NO SIGNIFICANT HAZARDS DOCUMENTATION

Unit 2 Technical Specification 6.4

Unit 2 Technical Specification 3/4.3.3.9, Tables 3.3-13 and 4.3-8

FIGURE 6.2-1
OFFSITE ORGANIZATION

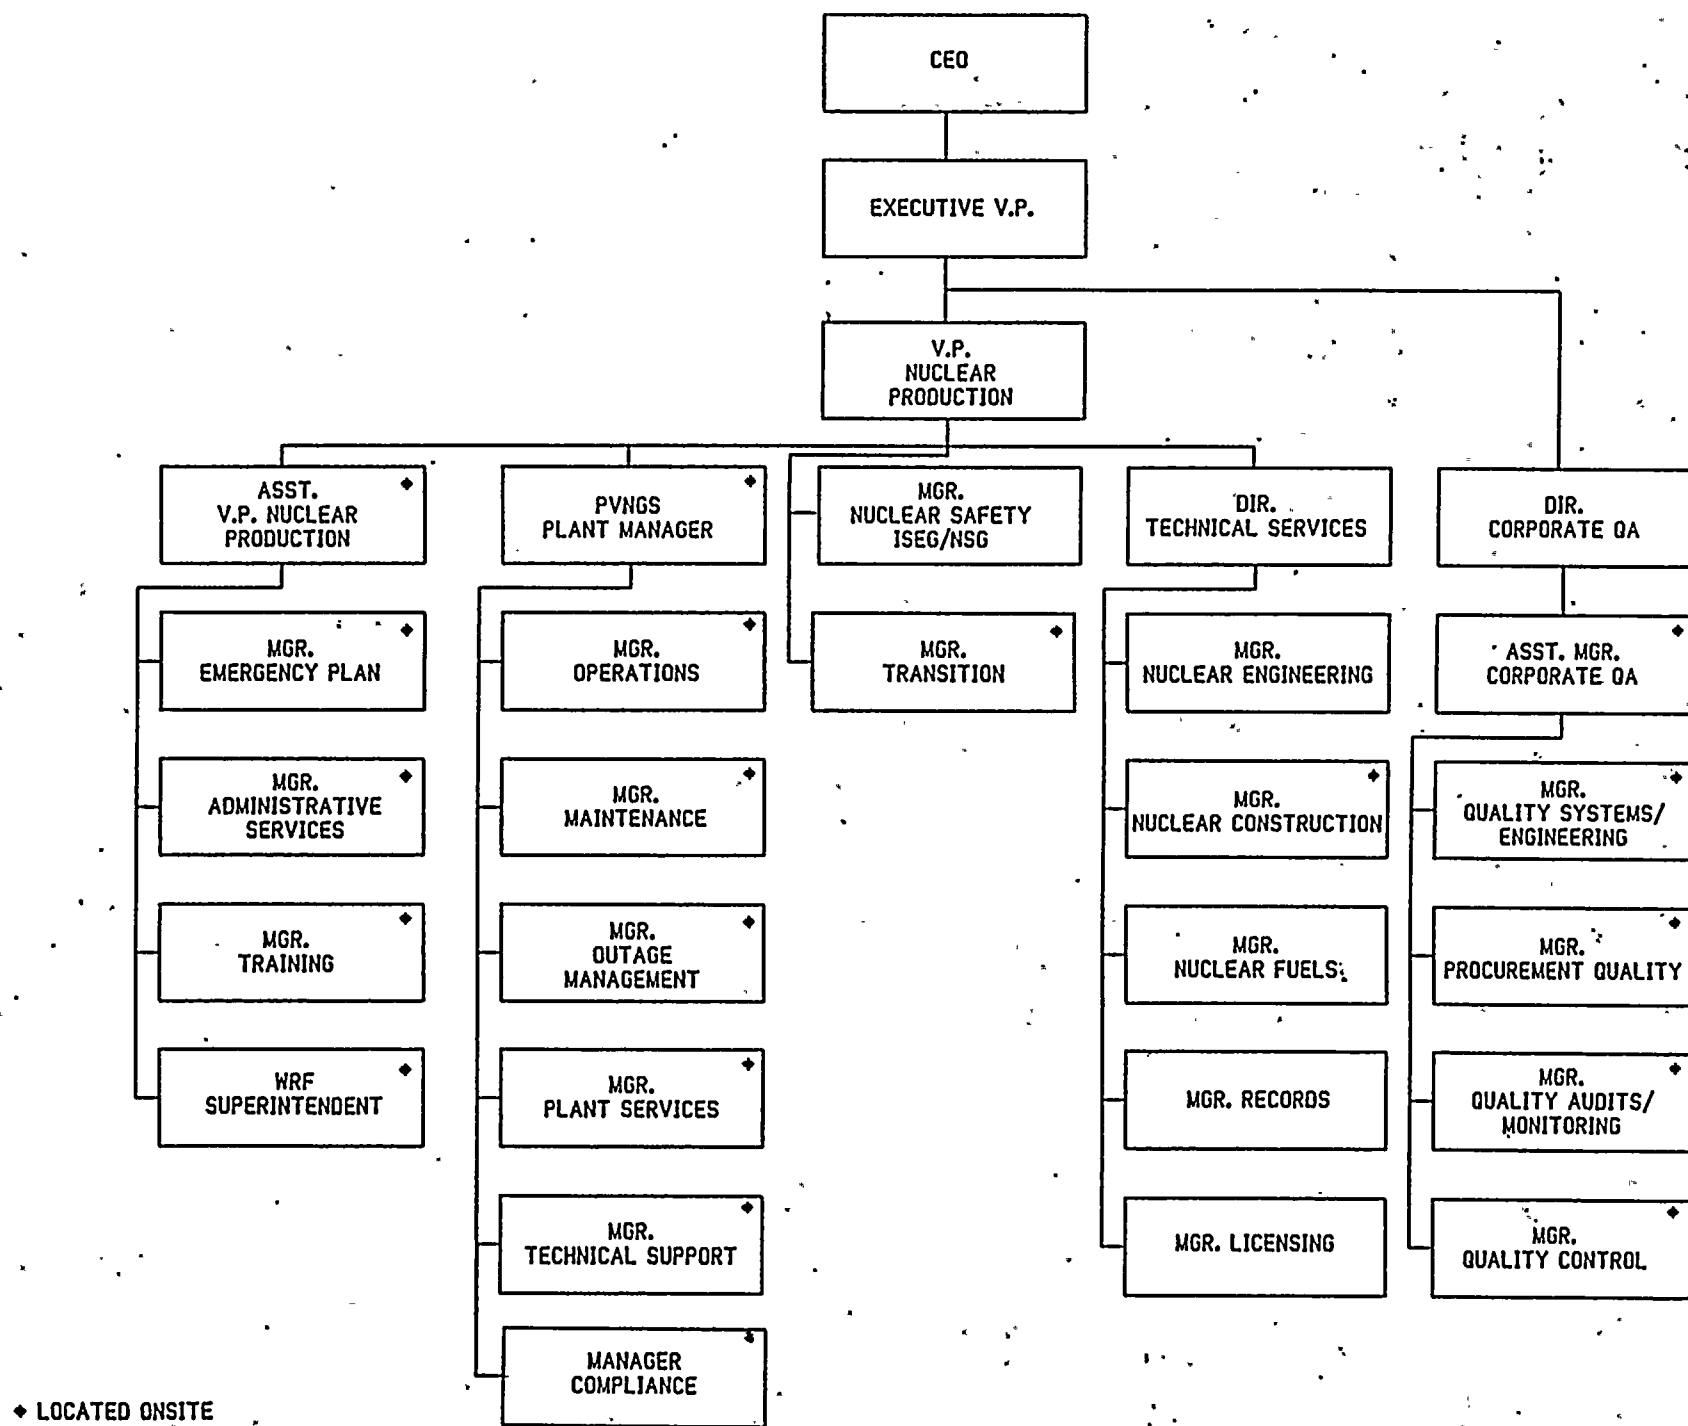
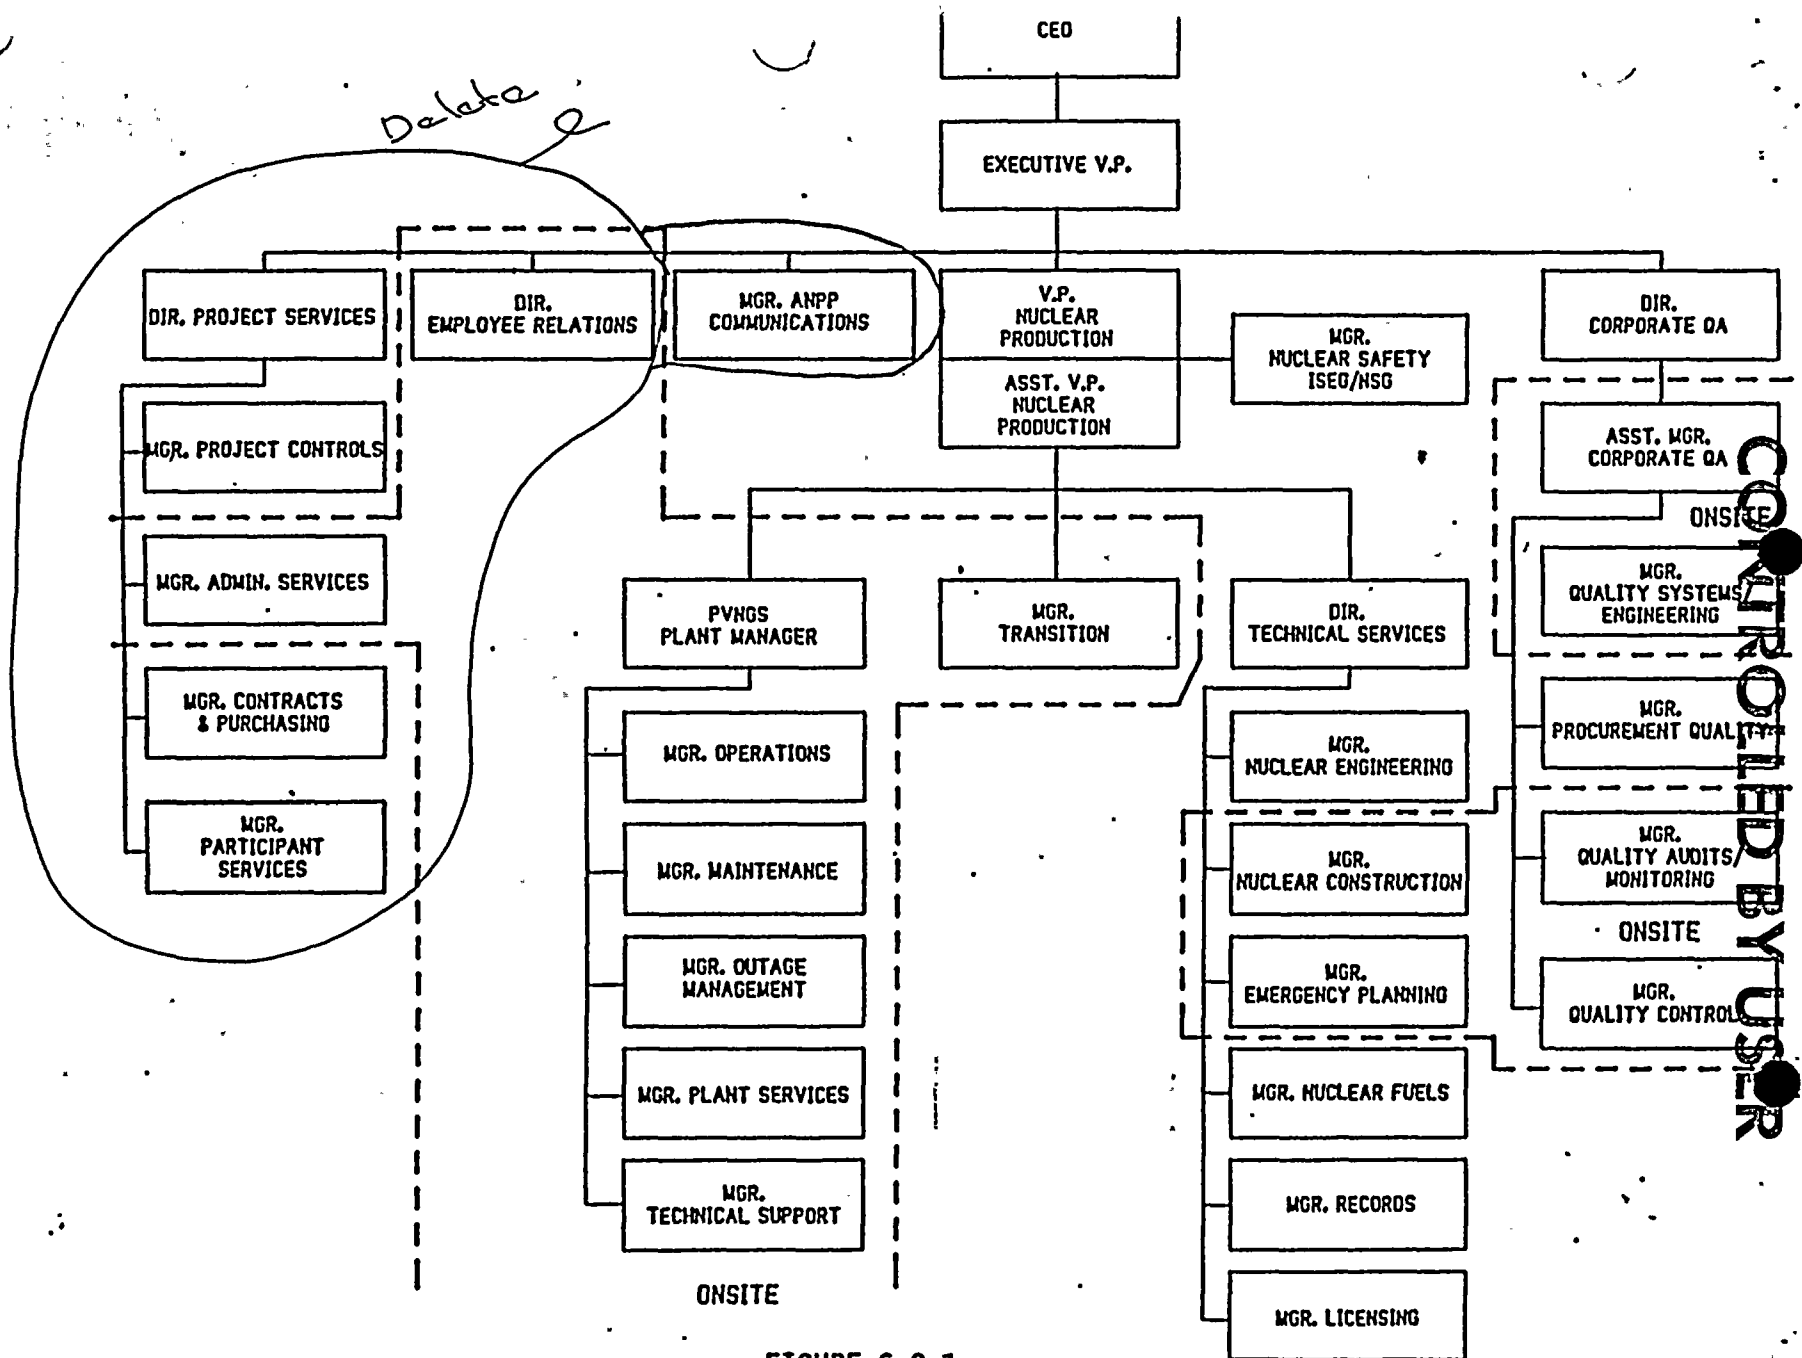
The major change is depicted on Figure 6.2-1. The Assistant Vice President, Nuclear Production, is shown separated from the Vice President, Nuclear Production, and is assigned direct responsibility for four support functions: Emergency Planning, Administrative Services, Training, and Water Reclamation Facility Operations. This change was made to allow those managers who have direct responsibilities for plant operation and safety to concentrate resources on those areas and to provide effective management for necessary support functions.

An additional change can be seen on Figure 6.2-1. The Compliance Department reporting to the PVNGS Plant Manager will now be headed by a manager with one or more supervisors reporting to him. This change is intended to increase the effectiveness of this group in responding to Licensee Event Reports and other interfaces with regulatory matters.
